Planning and regulatory committee

Date: **Wednesday 3 February 2021**

6.	<p>193878 - LAND OFF, KINGSTONE ROAD, CLEHONGER, HEREFORDSHIRE</p> <p>Application for approval of reserved matters following outline approval P141964/O (site for residential development of up to 90 dwellings with access, parking, public open space with play facilities and landscaping).</p>	29 - 94

MEETING:	PLANNING AND REGULATORY COMMITTEE
DATE:	3 February 2021
TITLE OF REPORT:	<p>193878 - APPLICATION FOR APPROVAL OF RESERVED MATTERS FOLLOWING OUTLINE APPROVAL P141964/O (SITE FOR RESIDENTIAL DEVELOPMENT OF UP TO 90 DWELLINGS WITH ACCESS, PARKING, PUBLIC OPEN SPACE WITH PLAY FACILITIES AND LANDSCAPING). AT LAND OFF KINGSTONE ROAD, CLEHONGER, HEREFORDSHIRE.</p> <p>For: Engie Regeneration Ltd and Stonewater Developments Ltd per Miss Kate Holden, First floor, South Wing, Equinox North, Great Park Road, Almondsbury, BS32 4QL</p>
WEBSITE LINK:	https://www.herefordshire.gov.uk/info/200142/planning_services/planning_application_search/details?id=193878&search-term=193878
Reason Application submitted to Committee – Applicant is a Council Development Partner

Figure 4: Suggested road frontage hedgerow and hedgerow tree planting scheme.

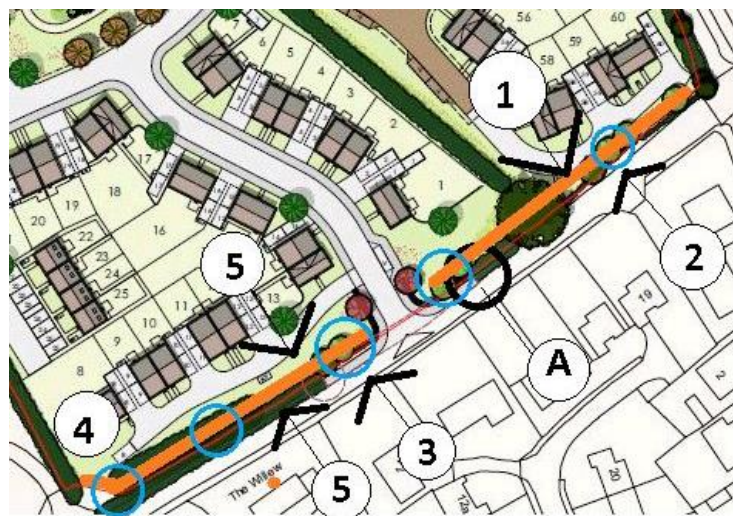
- The drawing (See figure 4, reference A) indicates that the footpaths on either side of the entrance road goes straight into the end of the hedgerow? This needs to be clarified.

- It is recommended to start a fresh, and create a hedgerow with hedgerow trees along the entire length of the development frontage. (Refer figure 4 for recommendations).

- 1 Plant a new hedgerow with hedgerow trees to maintain a strong continuous hedgerow.
- 2 Gap up redundant field opening to maintain a continuous hedgerow.
- 3 Integrate entrance trees (Hedgerow trees), that can be considered as part of the hedgerow language and forms the local landscape character of a countryside lane.
- 4 Gap up corner as part of new hedgerow planting.
- 5 Plant a suitable wildflower, ground flora and grass mix to provide biodiversity enhancement and to bolster the hedgerow ecology.

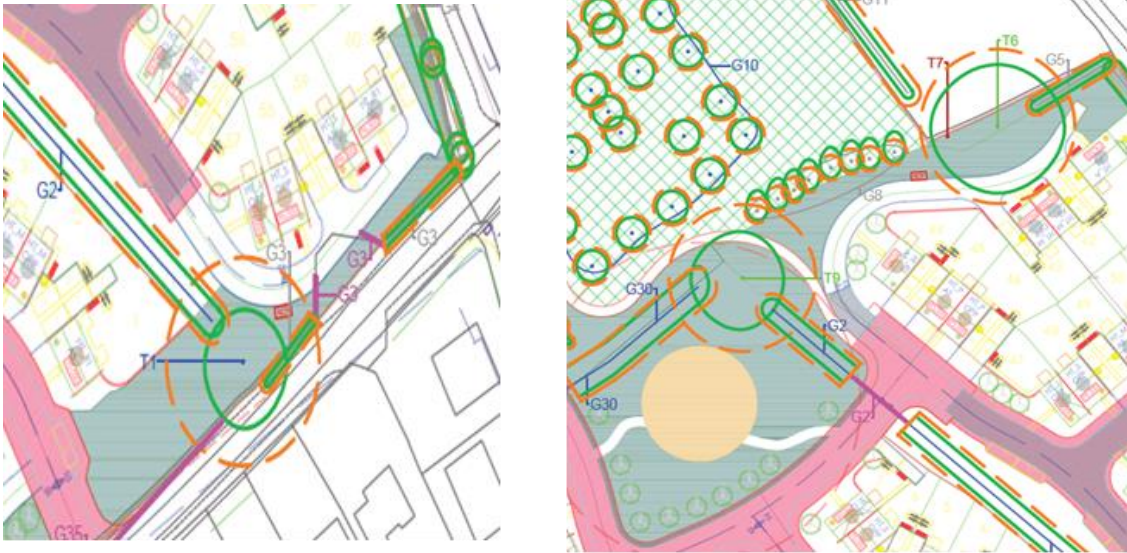
T1, T6 & T9 are three mature Oak trees which I would regard as integral landscape features to the site. All three have access roads, drainage infrastructure or plots which will be located within RPAs, T9 is affected to a lesser extent admittedly.

T1 – The access road extends 6m into the RPA which raises concerns for the long term condition of the tree. The formula for estimating the RPAs in BS5837:2012 Trees in relation to Design, Demolition & Construction isn't definitive and its is quite likely that a tree of this age and size has roots that spread considerably further than the 14m radius stated. It is also unlikely that the pattern of the root spread forms a perfect circle around the tree trunk. With the presence of the highway within a few metres I would suspect that the roots spread considerably further into the site than indicated.

T6 – Tree Protection Plan and Proposed & Planning Layout show that the access road will extend into the rooting area by approximately 7m which in my opinion is too excessive, especially when drainage routes will also be sited under the road.

I request amendments are made to the plan so the layout in the eastern corner of the site has a reduced impact on the trees T1 & T6.

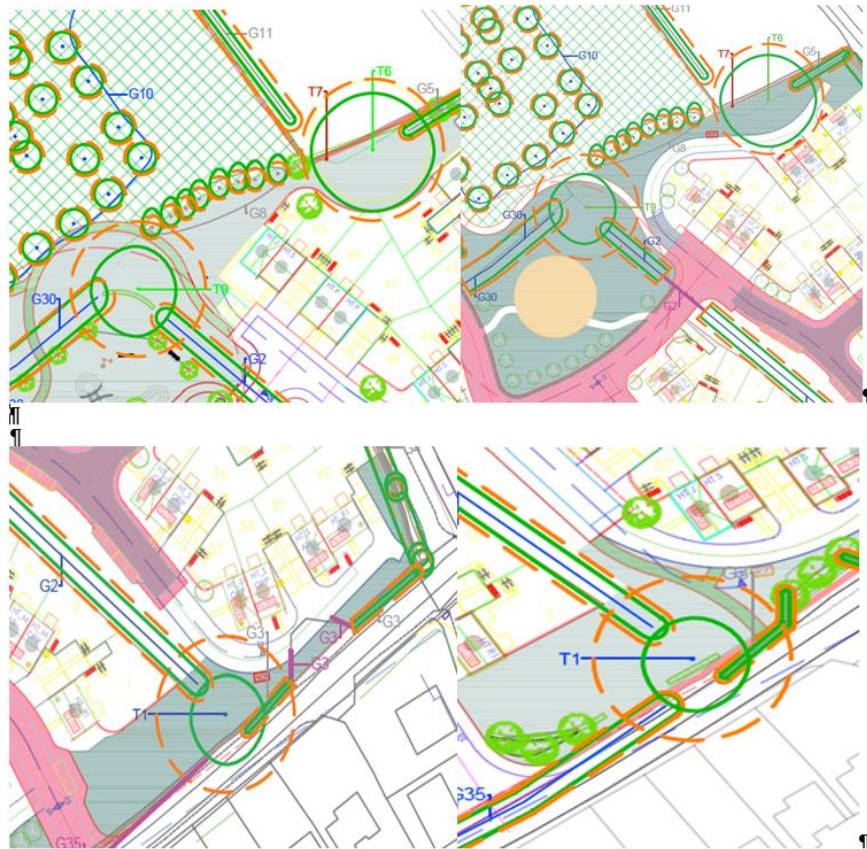
4.7.1 Principal Natural Environment Officer (Trees) (amended)
 Having viewed the amended plans I appreciate that my original reservations have been taken into account regarding T1, 6 & 9 which have recently been protected by a Tree Preservation Order.

The amended plans illustrate that the constraints on the trees is now reduced and therefore the application is compliant with policies LD1 & LD3 of the Herefordshire Core Strategy.

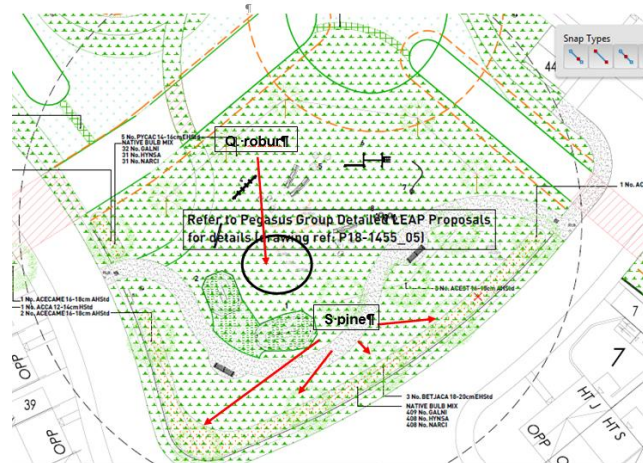
This green space is also adjacent to one of the large, TPO'd Oak trees and in my opinion this recreational space, central to the site should be populated with some Oak for continuity and the ecological/landscape benefits it offers.

I can appreciate that space is limited on the roadsides but there does appear to be a lack of tree planting here despite spaces being available. Would it be possible for the inclusion of more planting of small native ornamentals such as crab apple or hawthorn? Extra planting will enhance the character of the site as well as improve amenity value of the street scenes.

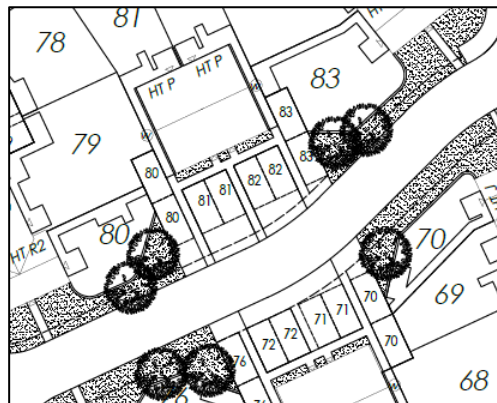
- The submitted adoption plan shows footways coloured grey and white, which ones are to be adopted?
- It states in your response that the footway adjacent to plots 66 and 67 (shown on concurrent reserved matters planning application plan) and on this planning application shown as plots 57 and 58 that an adopted footway could not be provided due to it being a private drive. Is this within the ownership of the applicant? What is stopping it being adopted, please provide further clarification. This route is pretty vital as the walking distance round will be quite large for a portion of the site. In terms of a mown path, this would not be an option all year round as a result could not be relied upon to provide a full time link. Additionally the route will not have a public status so presumably the management company could close it off at some point in the future

- The access adjacent to plot 28 would be used as an access to the adjacent land, Is this land to be used for agricultural purposes? If so would large vehicles need to access the site though this access?
